Certified Action of the City of Raleigh Planning Commission

Case File / Name: SP-48-10 / Raleigh Orthopaedic

Nature of Case: The construction of a 98,468 medical office building on a recently subdivided 7.54 acre parcel zoned Office & Institutional-1, located inside the City limits.

SP-48-10 Raleigh Orthopaedic - Site Plan

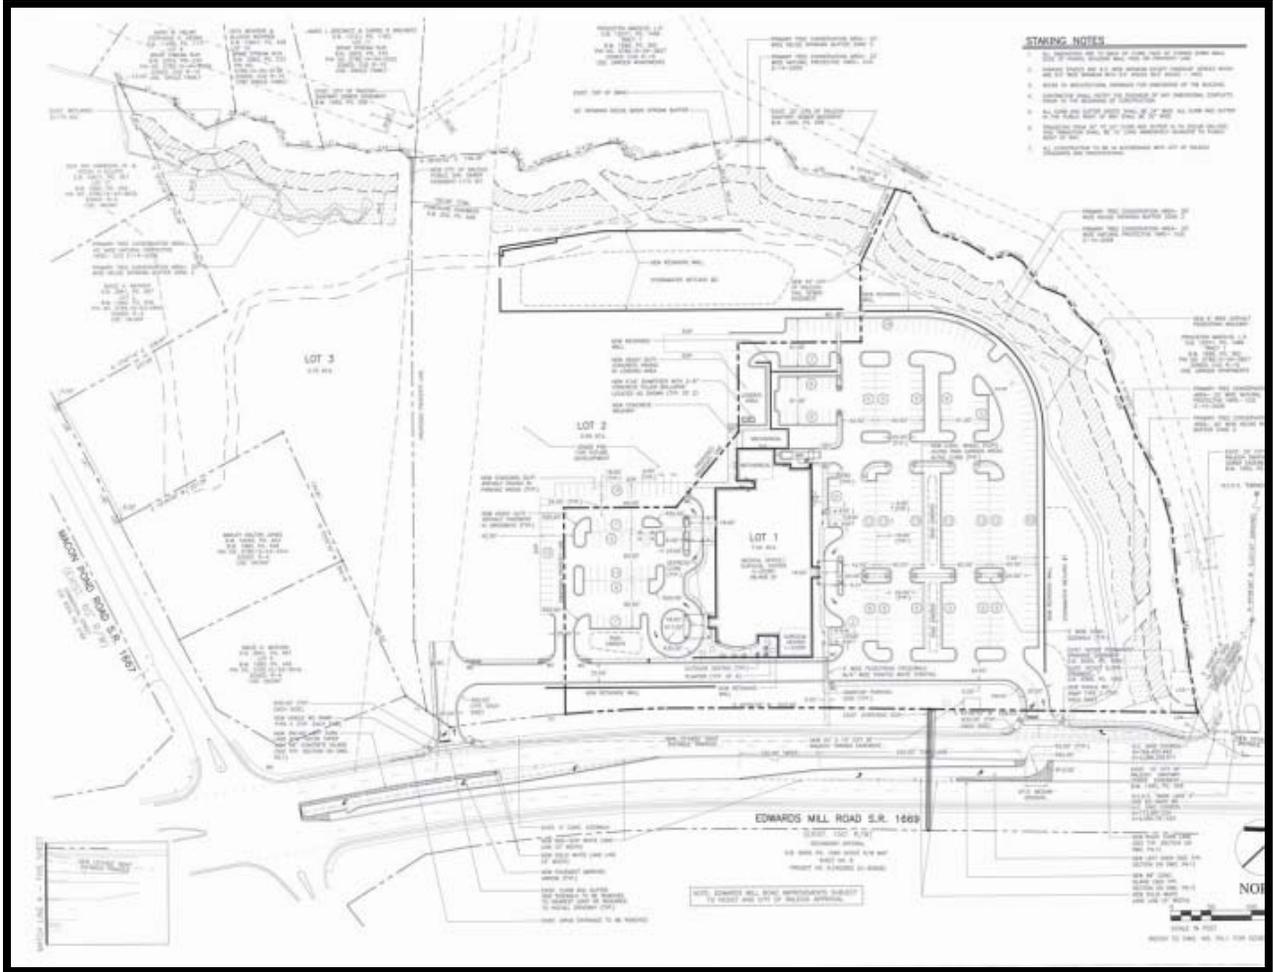
The Appearance Commission has made the following comments on this preliminary plan. Shown below are comments and applicant responses:

<u>Comment</u>	<u>Response</u>
<p>1. The committee recommends that the office building’s east façade (facing Edwards Mill Road) exhibit similar design presence and detail as the south-facing facade (perpendicular to the street) [commensurate with code Sec. 10-2132.2(d)(2)], through such measures as but not restricted to:</p> <ul style="list-style-type: none"> • Providing greater architectural prominence to the building entrance facing the road (e.g., adding a larger canopy). • Alter the articulation and materials treatment in the central section of the east wall to emulate those of the south elevation (e.g., increase amount of 	<p>As you will notice, the second building has been removed from the plans. The Ambulatory Surgical Center (ASC) has been combined with the Medical Office Building (MOB) to create one building. Since both uses operate independent of the other, the building has been design with the ASC located on the 1st floor with access to the building from the south side of the building. The MOB likewise has its own independent entrance located at the 2nd floor on the north side of the building. The MOB entrance will be similar to the previous design submitted, with a drop off canopy and window fenestration at the elevator lobby on each floor.</p> <p>The ASC will also have two drop of canopies and small windows along the south façade at the patient recovery</p>

<p>fenestration and vertical lines/ surfaces of contrasting color; bump out/ curve central section of the façade).</p>	<p>bays. The waiting area will have a curved glass wall similar to the previous design for the stand-alone ASC building.</p> <p>The ASC will have the light colored accent base course and brick veneer above. The remaining stories above will have accent bands of masonry and brick veneer. The south facade of the building will have sunscreen devices over the windows on the larger windows of the MOB on the upper three floors.</p>
<p>2. Provide greater visual continuity between the buildings' façade design by changing the lower base courses of brick circling the surgery building to the lighter-color material circling the first floor of the office building [commensurate with code Sec. 10-2132.2(d)(6)].</p>	<p>The revised project will provide a single building of unified design and appearance. The light colored accent masonry will be utilized on the lower level ASC base course, accent bands to define the 3 upper floor levels, accent bands at the crown molding along the roof edge and at the three stair towers. Accent bands will also be utilized at all window heads and sills. The stairs on the east elevation facing Edwards Mill Road will have the light color accent masonry on all surfaces to provide a focal point on the end of the building. Additional windows will be added in the stairwell.</p>

<p>3. Given the change in elevation across the site, as an alternative to installing one tall retaining wall at the rear of the site and one large, flat parking lot atop it, consider terracing the parking area (i.e., stepping-down the lot by double bays, with access between via low-slope ramp/ drives) [commensurate with code Sec. 10-2132.2(d)(2) & (4)].</p>	<p>The redesign of the site has taken this into consideration and has resulted in terracing the rear parking. It now transitions from the upper level MOB parking area to the lower</p>
<p>4. Enhance the pedestrian experience internal to the parcels [commensurate with code Sec. 10-2132.2(d)(1), (2), &/or (6)]:</p> <ul style="list-style-type: none"> · Enhance the design of the rear building entrances for greater visual prominence (e.g., add canopies/ awnings, provide wider sidewalk connections and enhanced landscaping, etc.) · Given the time site visitors may spend waiting, and the expected number of staff, 	<p>The redesign has resulted in a stronger entrance appearance for both the ASC and the MOB making it easier for patients to find their way. Additional pedestrian connections have added, a walking/jogging trail around the site, and added landscaping features including the creation of new bioretention islands (rain gardens) in the MOB parking lot and south entrance to the ASC</p>

<p>redesign the space between the buildings as an amenity: provide direct access to it via exterior building doors, install enhanced landscaping, include benches, etc.).</p>	
<p>5. Provide direct, straight-line pedestrian connections between the public sidewalk along Edwards Mill Road and the closest entrances to each building [commensurate with code Sec. 10-2132.2(d)(1) & (5)]. Install steps if needed.</p>	<p>An additional pedestrian connection to the public sidewalk has been added as requested.</p>
<p>6. Break up the wide length of parking fronting the site along Edwards Mill Road with two or more planting islands [commensurate with code Sec. 10-2132.2(d)(2)].</p>	<p>All parking along Edwards Mill Road has been eliminated.</p>
<p>7. Widen crosswalks for greater presence and visibility [commensurate with code Sec. 10-2132.2(d)(5)].</p>	<p>Although widened crosswalks are not planned, the site plan does make every effort to coordinate with existing and planned public facilities as described in the Code. coordinate with existing and planned public facilities as described in the Code. rear parking. It now transitions from the upper level MOB parking area to the lower lever ASC parking area.</p>
